SUPPLEMENTAL RESPONSE TO REQUEST FOR ADDITIONAL INFORMATION

APR1400 Design Certification

Docket No. 52-046

RAI No.: 129-8085
SRP Section: 03.08.01 – Concrete Containmentment
Application Section: 3.8.1
Date of RAI Issue: 08/05/2015

Figure 1 Section of Containment around IRWST

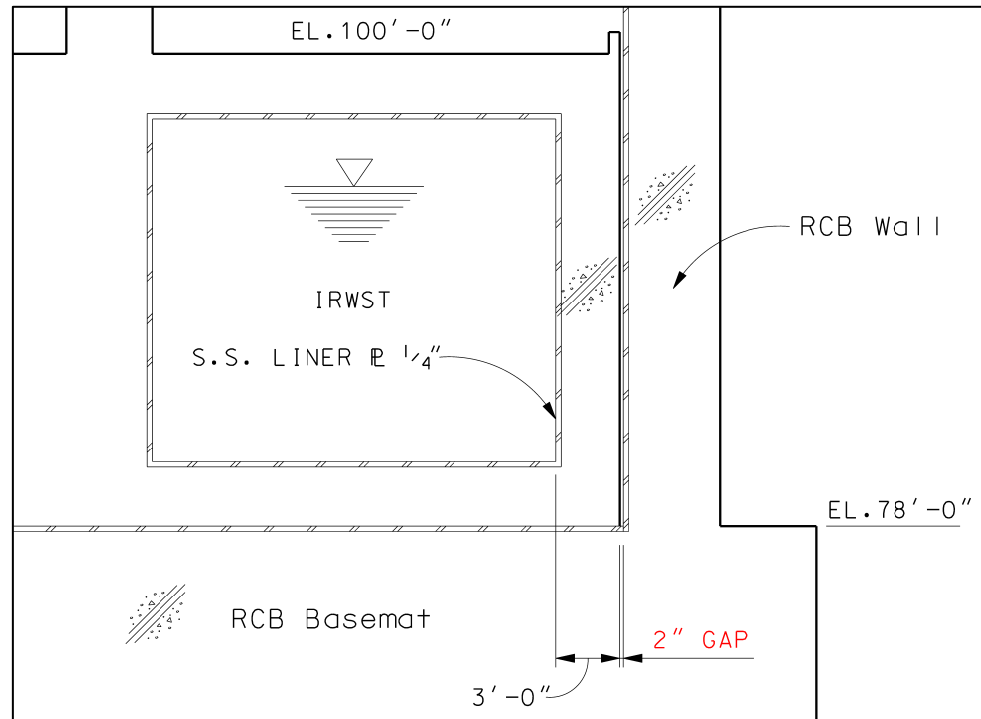
- e. Explain where in DCD Sections 3.8.1.3 and 3.8.3.3 the load descriptions and load combinations for consideration of safety/relief valve actuation loads on the containment and containment internal structures are described and whether or not the safety/relief valve actuation loads include potential direct loads on the structures and potential building dynamic response loads.

- e. DCD Tier 2, Subsection 3.8.1.3 does not describe pilot-operated safety relief valve (POSRV) actuation load since POSRV actuation loads are not applied on the containment wall. The IRWST is separated from the containment wall by a gap of 2 inches, as shown in Figure 1 below. Thus, there is no connection to transfer POSRV actuation loads to the containment wall. Therefore, POSRV actuation loads are not applied to the containment basemat through the containment wall. DCD Tier 2, Subsection 3.8.3.1.8 will be revised, indicated in the Attachment 1 associated with this response.

For the containment internal structures, POSRV actuation loads are transmitted through the pressurizer (DCD Tier 2, Subsection 3.8.3.1.4 and 3.8A.1.4.3.1.3). Therefore, the loads are treated as a kind of reactor coolant system (RCS) support load. For RCS support loads, the governing load, either POSRV actuation or branch line pipe break (BLPB) load, has been applied on the pressurizer enclosure room wall and slab.

For POSRV discharge load, a hydrodynamic pressure which is generated by the explosion of air during POSRV discharge, is applied to the wall and bottom slab of the IRWST through the 12 spargers (DCD Tier 2, Subsection 3.8A.1.4.3.1.3). This hydrodynamic pressure load is a short transient pressure time history during the expansion and collapse of the air bubble. The air bubble transient pressure time history is directly applied to the wall and bottom slab of the IRWST using the normalized factor which is considered for the distance between the spargers and structures.
